**NOTICE OF A REGULAR MEETING
BONDURANT PLANNING AND ZONING COMMISSION
AUGUST 8, 2024**

TITLE: Resolution PZ-240808-23 - Considering approval of the site plan for Parcel 2024-102.

TITLE: Resolution PZ-240808-24 - Considering approval of the site plan for Featherstone Apartments.

FEATHERSTONE APARTMENTS
DIMENSION PLAN

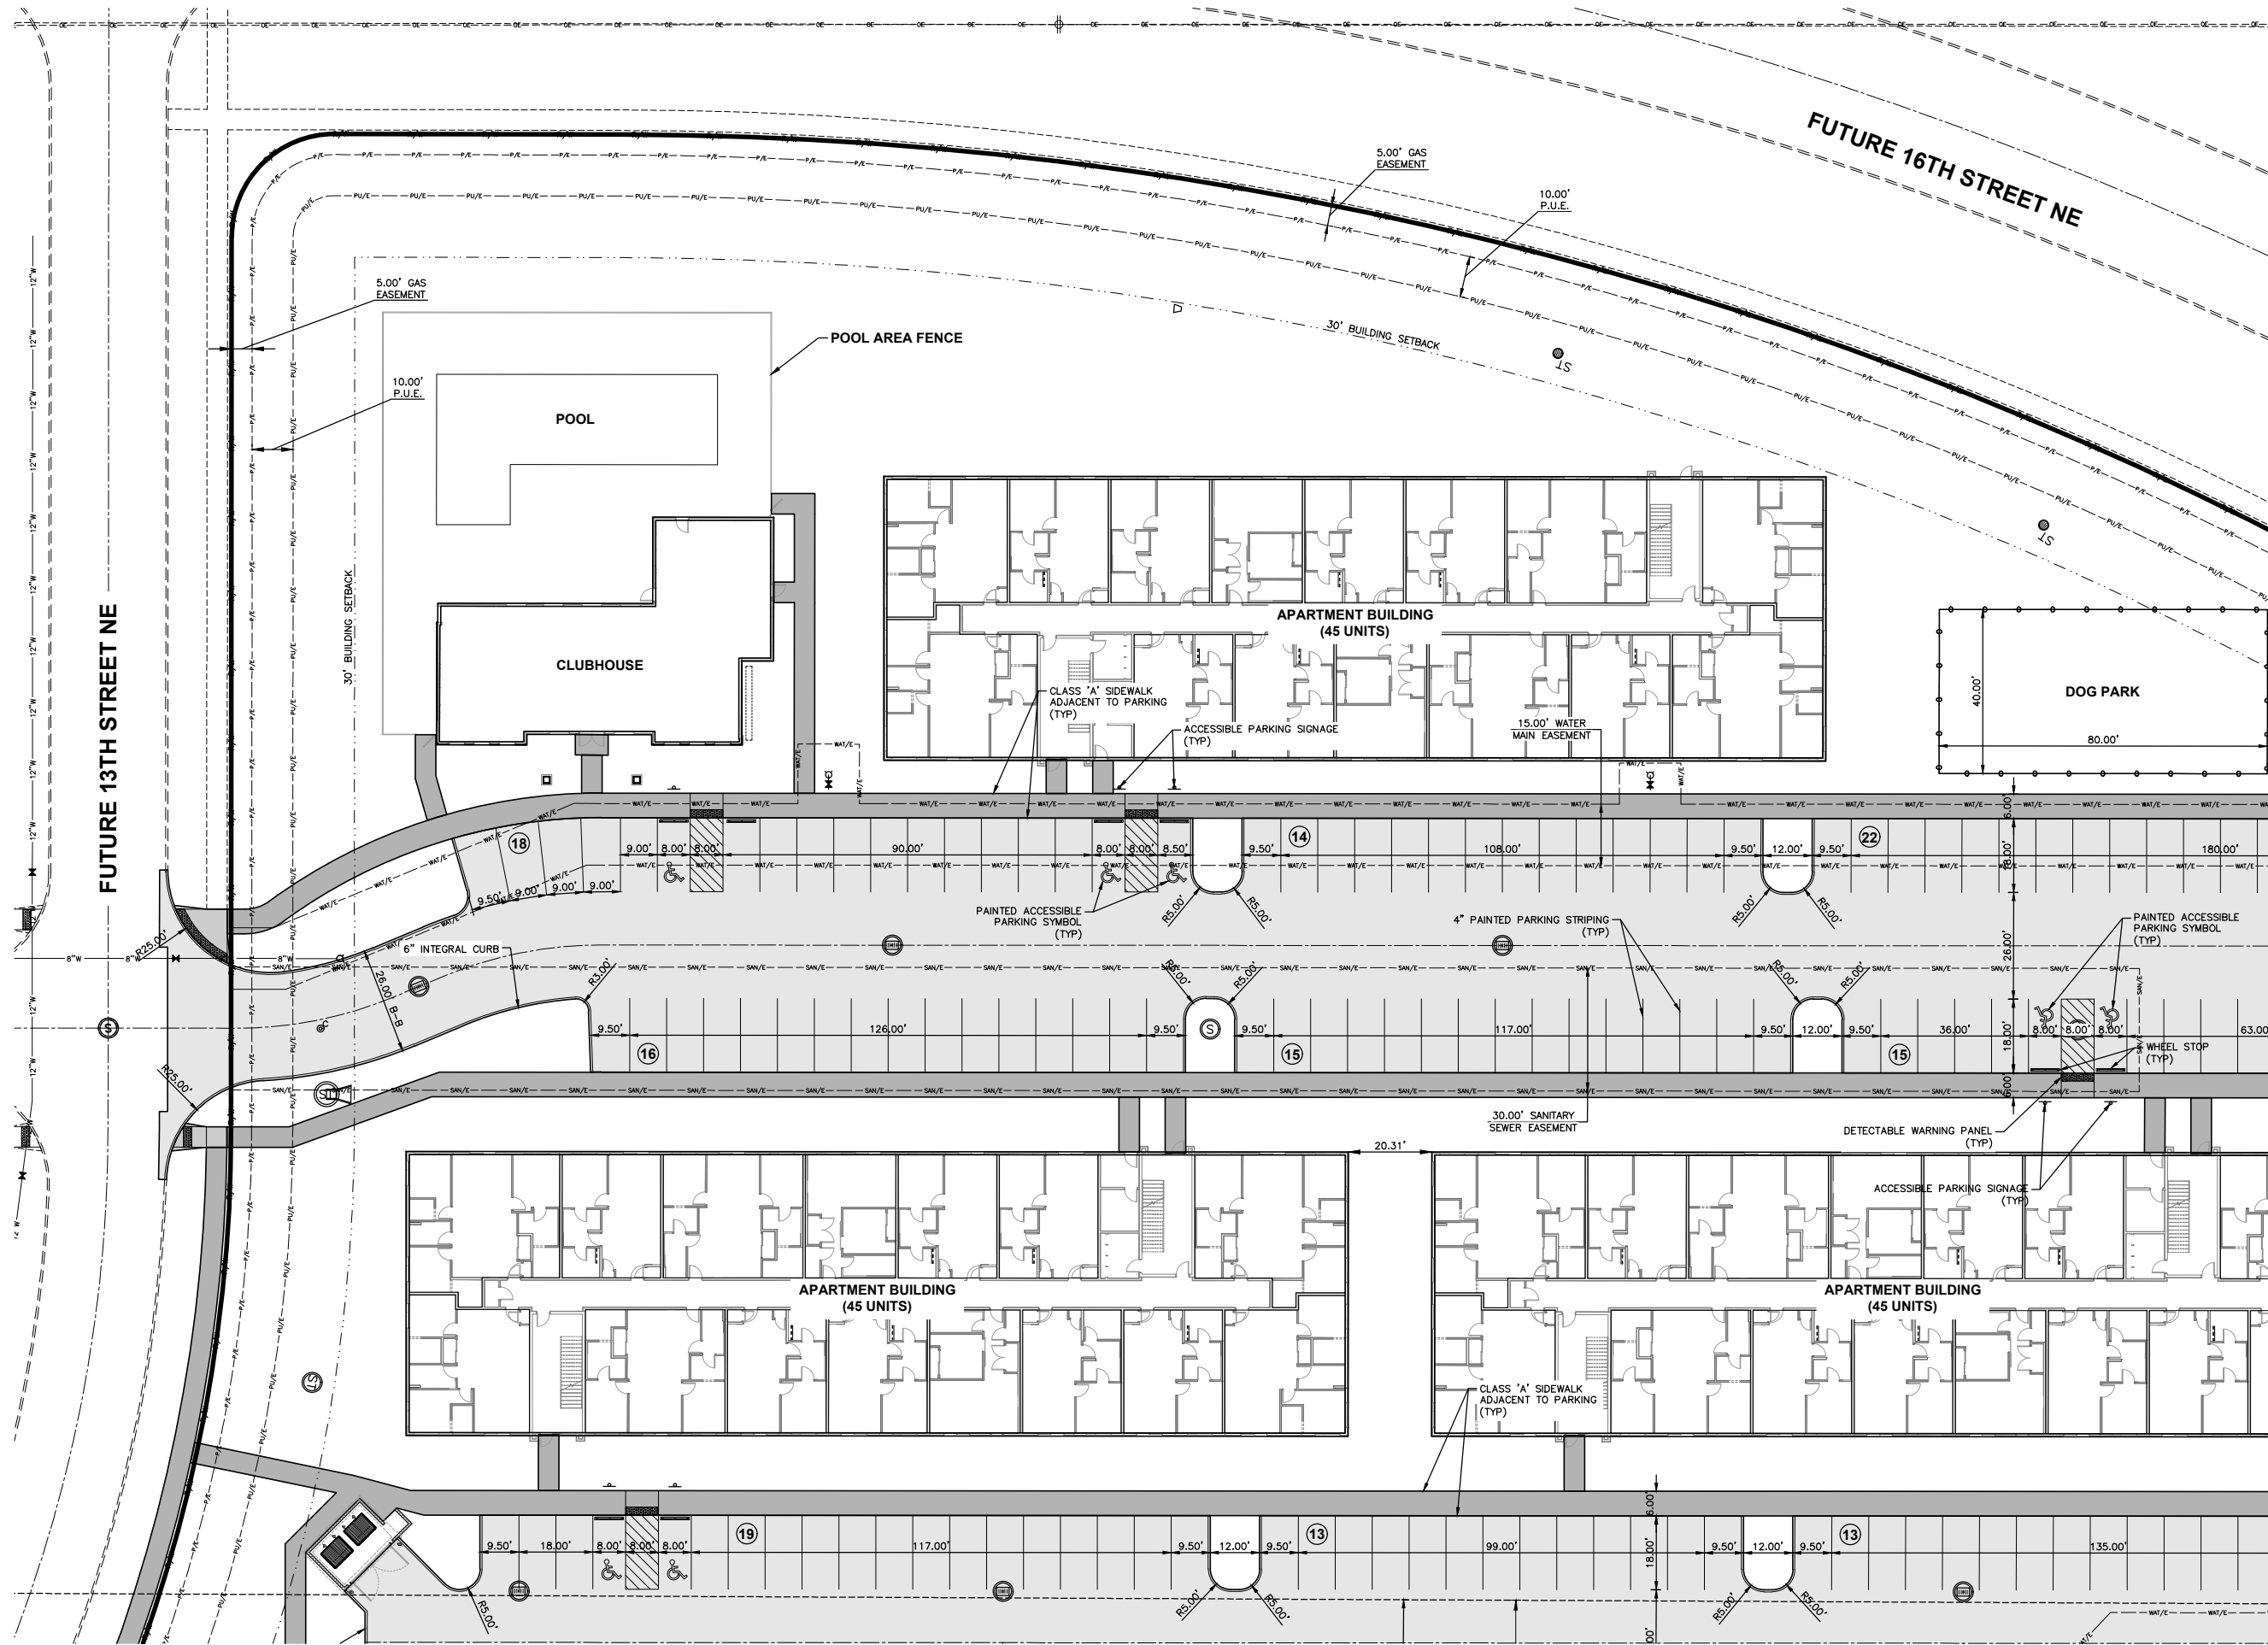
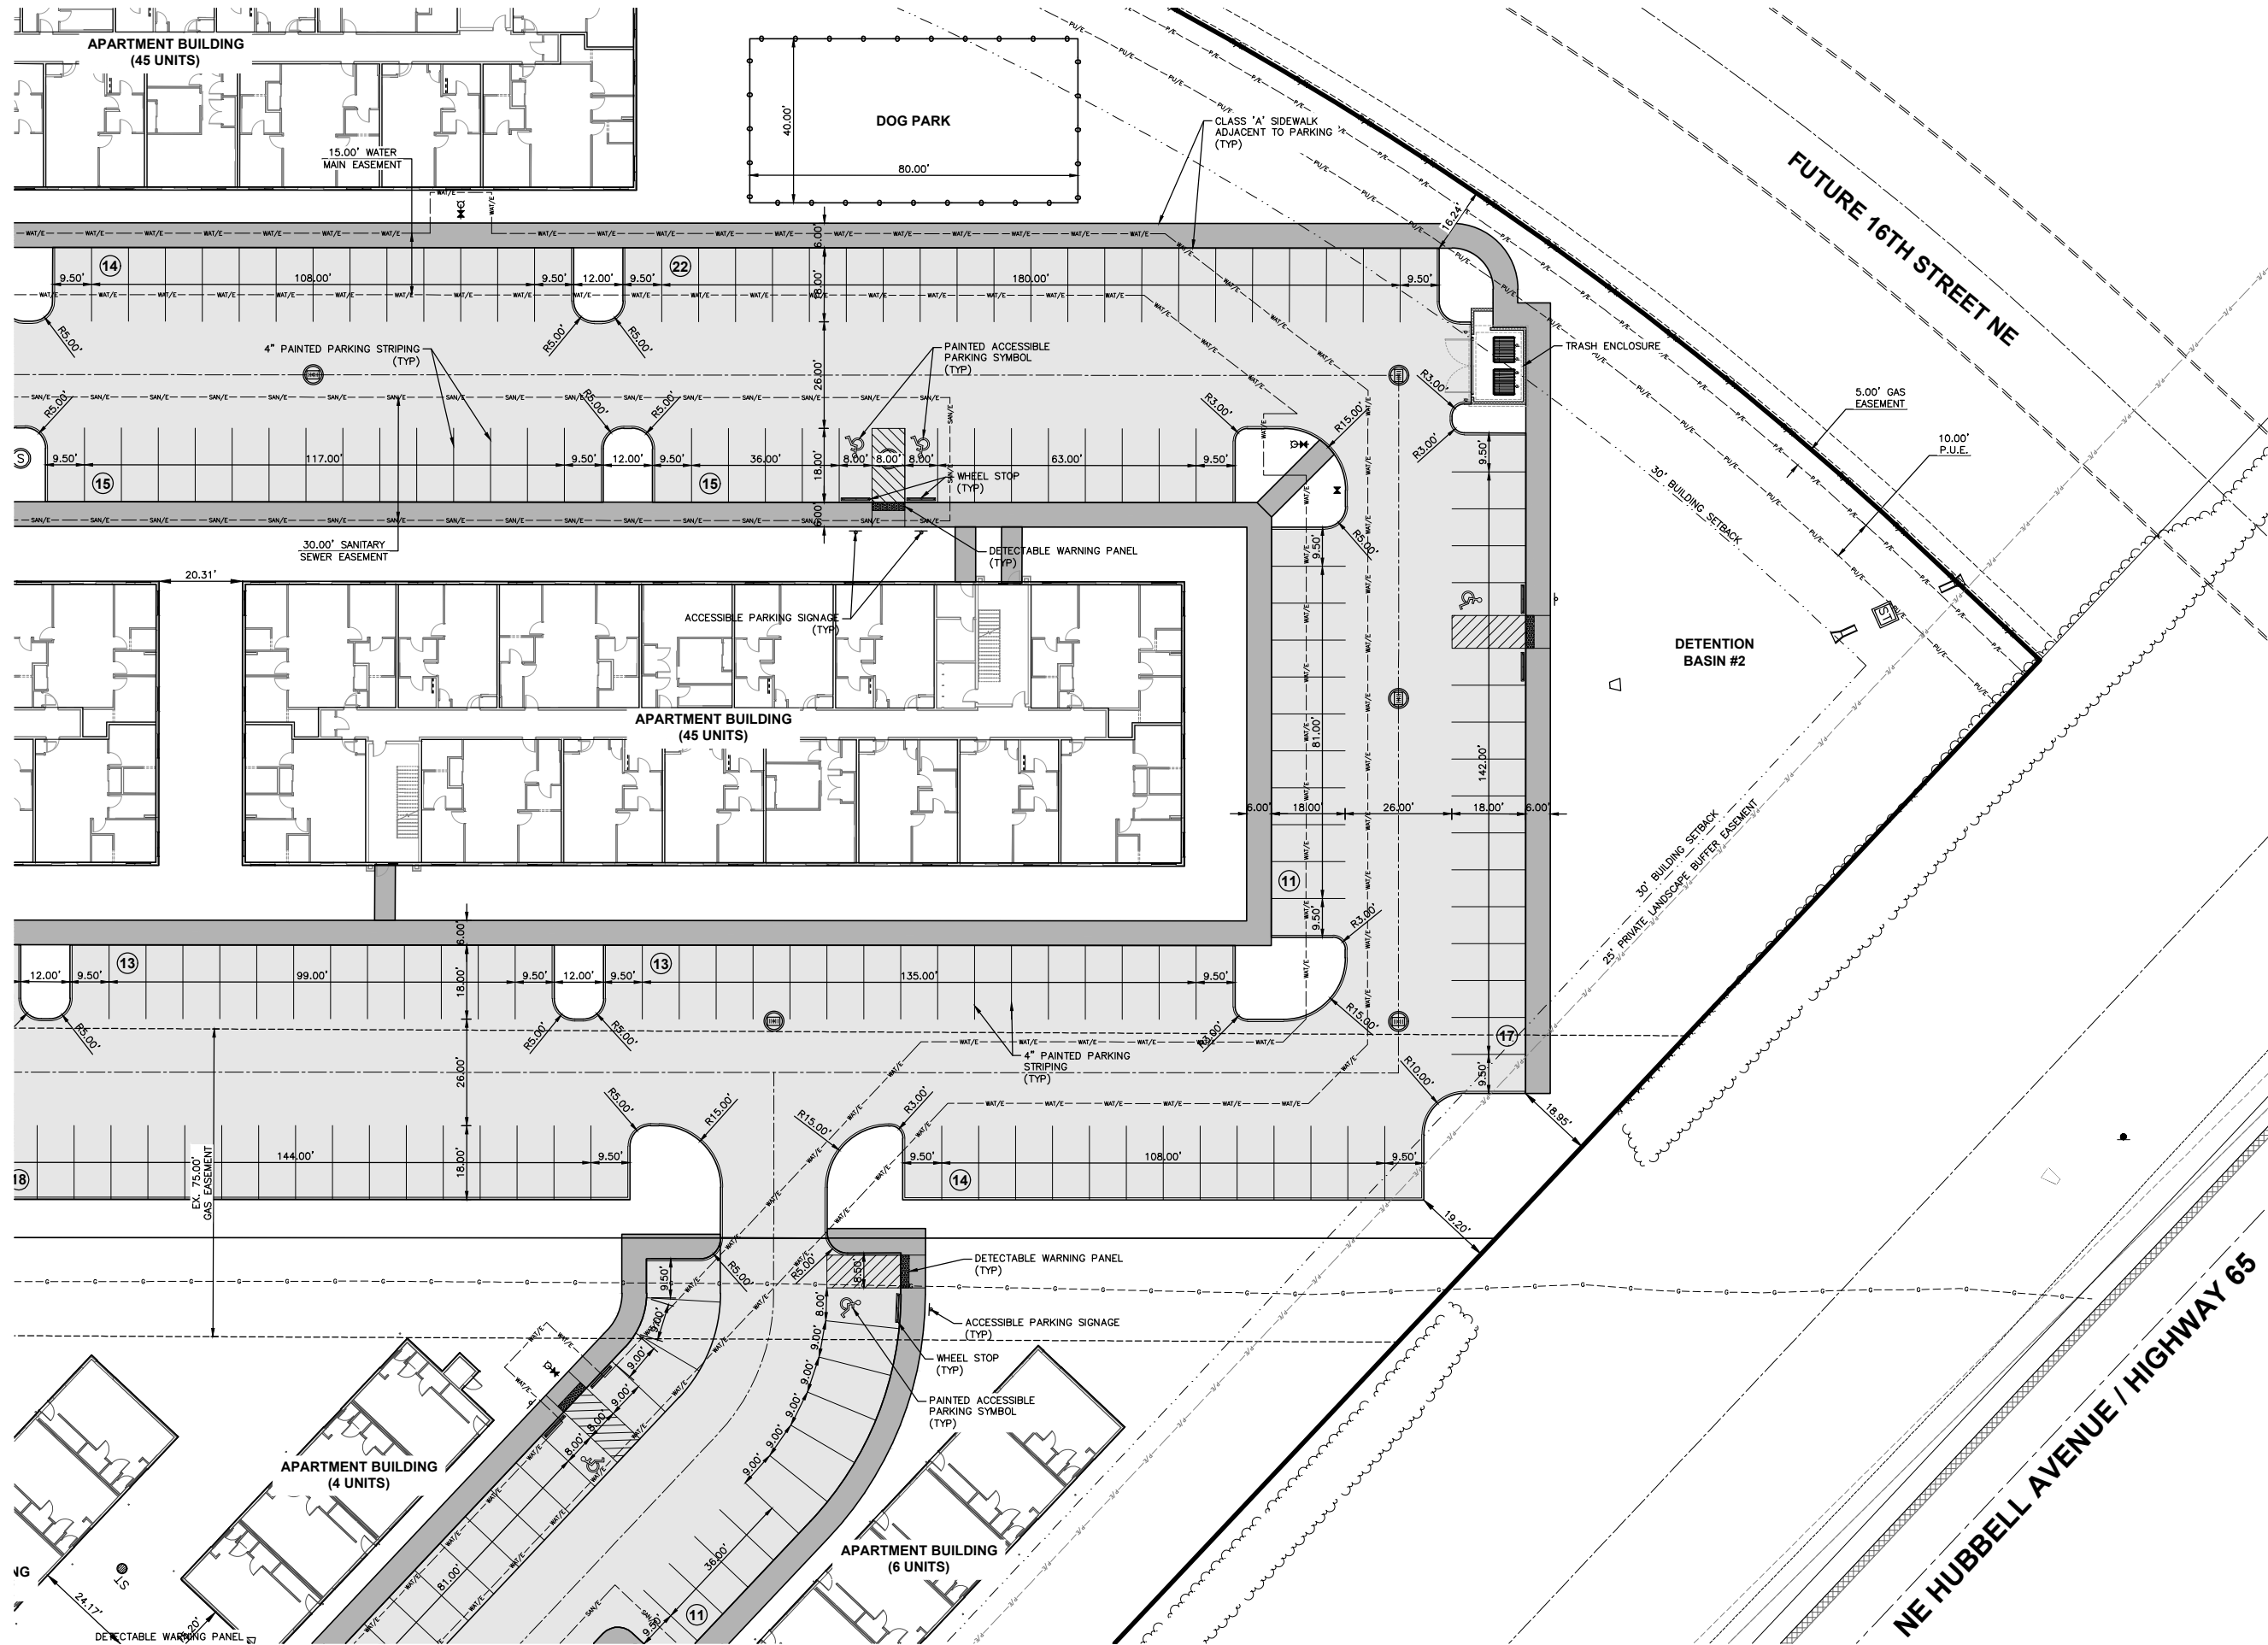
- The site plan does not show the correct road proposed alignment of 16th Street NE (AKA NE 86th Avenue) intersecting with Highway 65. The proposed draft intersection realignment route shown in the 2021-approved PUD Conceptual Plan and the 2021-approved Preliminary Plat has since changed per the City's further investigation of traffic safety in this area while also factoring in feedback received from the Iowa Department of Transportation. The Bondurant City Council hired Veenstra & Kimm in August 2022 to create a conceptual design of the proposed relocated intersection area well in advance of this proposed FY2028 street construction project, where the updated draft route cuts further south than what the developer is proposing on the attached site plan. The developer has known of this updated draft alignment since 2022 and is referencing the outdated proposed intersection alignment in its submitted plans.

1. Public Works - reviewed and all comments have been addressed, except for the following: the site plan does not show the correct road alignment of 16th Street NE (AKA NE 86th Avenue) intersecting with Highway 65.
2. Engineering – reviewed and all comments have been addressed, except for the following: the site plan does not show the correct road alignment of 16th Street NE (AKA NE 86th Avenue) intersecting with Highway 65.

Staff recommends tabling the submitted site plan until the correct road alignment of 16th Street NE(AKA NE 86th Avenue) intersecting NE Hubbell Avenue is shown.
